Runways 16L/16R Vital to LGB for General Aviation and Aviation in General

LGB 3-RUNWAY PROPOSAL IS NOT THE SOLUTION

LGB Proposed 3-Runway Configuration

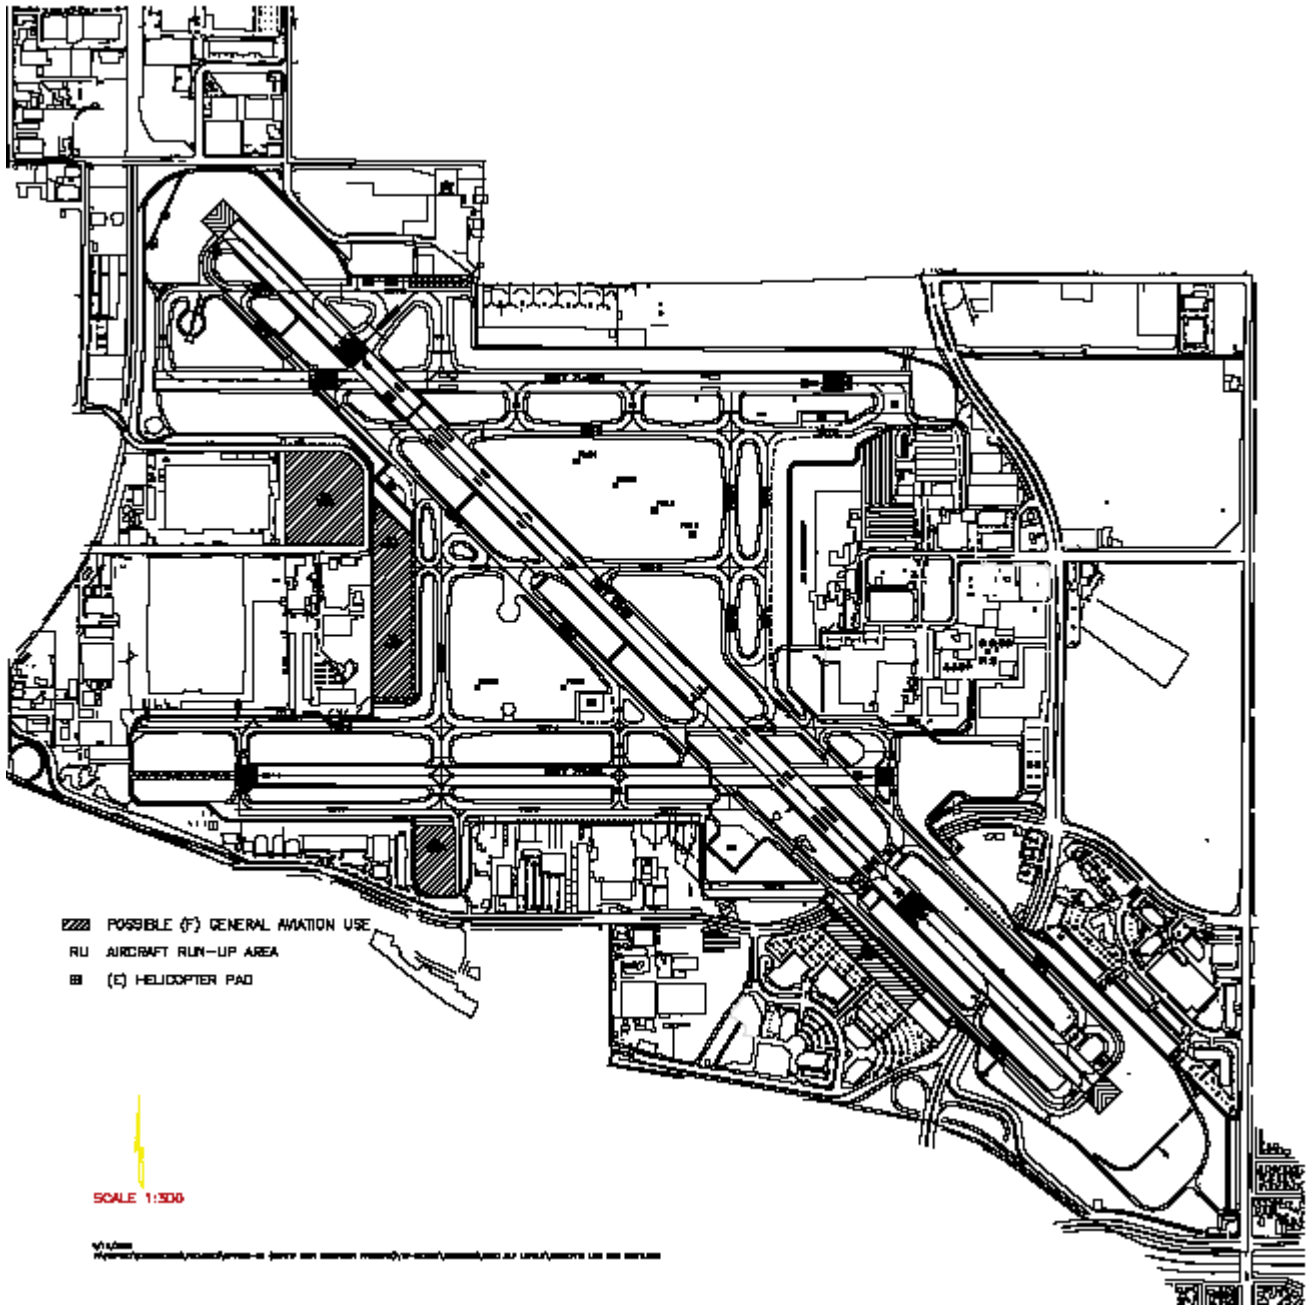
Apparently, the design concept for the LGB 3-Runway proposal is attempting to incorporate 90 degree intersections, reducing the number of entry and exit points for each runway and taxiway, and reducing the number of high energy runway/taxiway crossings. This standard doesn't seem to be in the CAST report, nor the Call to Action. If these are concepts for the design of a new airport, it should not be deemed as a guideline for an established airport.

I had originally suspected that closing Rwy 16L/R was to save money on the upkeep of the runways. But with the proposed configuration, unless there is a huge cost saving between runway and taxiway maintenance, there doesn't seem to be that much less asphalt. AND THEREIN LIES THE PROBLEM. It is no less confusing! Exhibit E shows that the number of runway exit/entry points is not reduced; it has in fact increased. And Exhibit F shows that the number of high-energy intersections is the same. It bears reminding that if Rwy 16L/R are in use, Rwy 25L/R are not in use. Except in the rare case of an emergency operation, there are at most 3 runways in use at LGB at any one time.

The LGB 3-Runway proposal does not consider local ordinance which prohibits touch-and-gos on Runway 30/12, nor letters of agreement between SoCal Tracon and LGB tower to sequence air carrier traffic for Runway 30. Aircraft do not get handled by LGB tower for Runway 30/12 without a handoff from Approach Control. General

Removal of the runways is not only a safety hazard during crosswind conditions, it also removes landing options in case of an emergency; "Cleared to land any runway" has fewer options under the LGB 3-Runway proposal.
